DATE: August 5, 2021

TO: Comprehensive and Neighborhood Planning Committee

FROM: Menaka Mohan, Principal Planner, Planning and Economic Development (PED)

RE: Summary of public comments and recommendation on proposed amendments to Open Space Lot Specific Standards for the Ford Site Zoning and Public Realm Master Plan (Ford MP)

Lot Coverage Bonus for Green Roof Areas

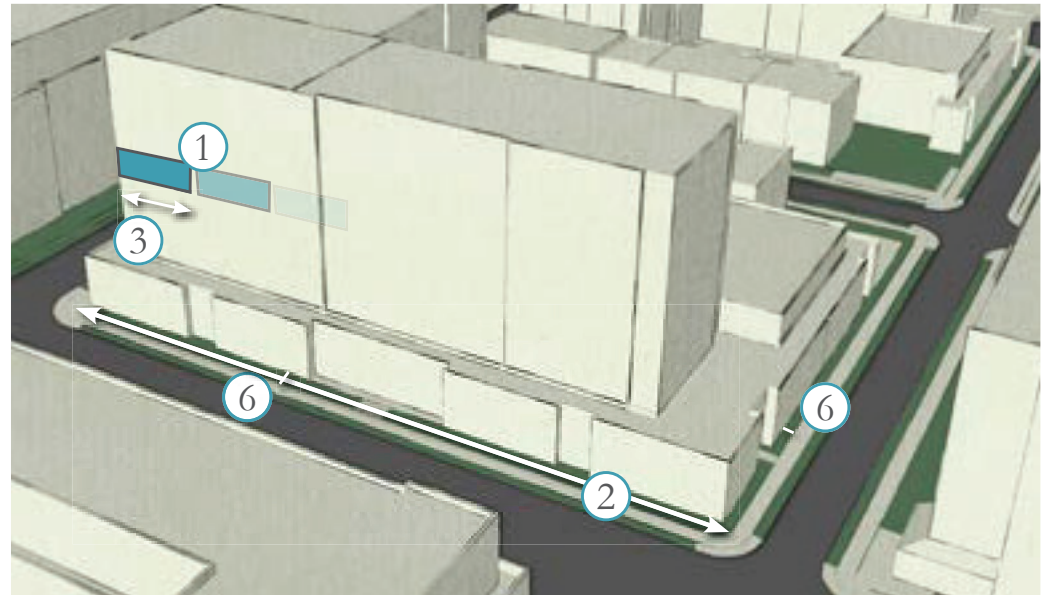
Functional Green Roof Area shall be defined as area atop a roof ~~surface~~ on a building, open to the sky and air, ~~which is surfaced~~ with soil and living plant materials for the purpose of retaining rainwater and absorbing heat from sunlight. The depth of soil and planted material shall be at least two (2) inches to be considered Functional Green Roof Area.

~~Where a rooftop surface includes Functional Green Roof Area, visible from the public right of way if below the third floor, adjacent open air outdoor space intended for use by building occupants or other persons that does not meet the definition of Functional Green Roof Area, such as a patio or deck, is eligible to meet up to 50% of the open space requirements of the property/site, as measured in gross square feet of the usable adjacent space. All such usable outdoor space shall be set back at least one (1) foot from all outer roof edges, and shall be located and oriented in relation to adjacent properties to minimize potential visual, noise and privacy impacts to abutting uses.~~

Projects that provide Functional Green Roof can receive a 1% lot coverage bonus for every 1% of Functional Green Roof provided, up to a 5% lot coverage bonus
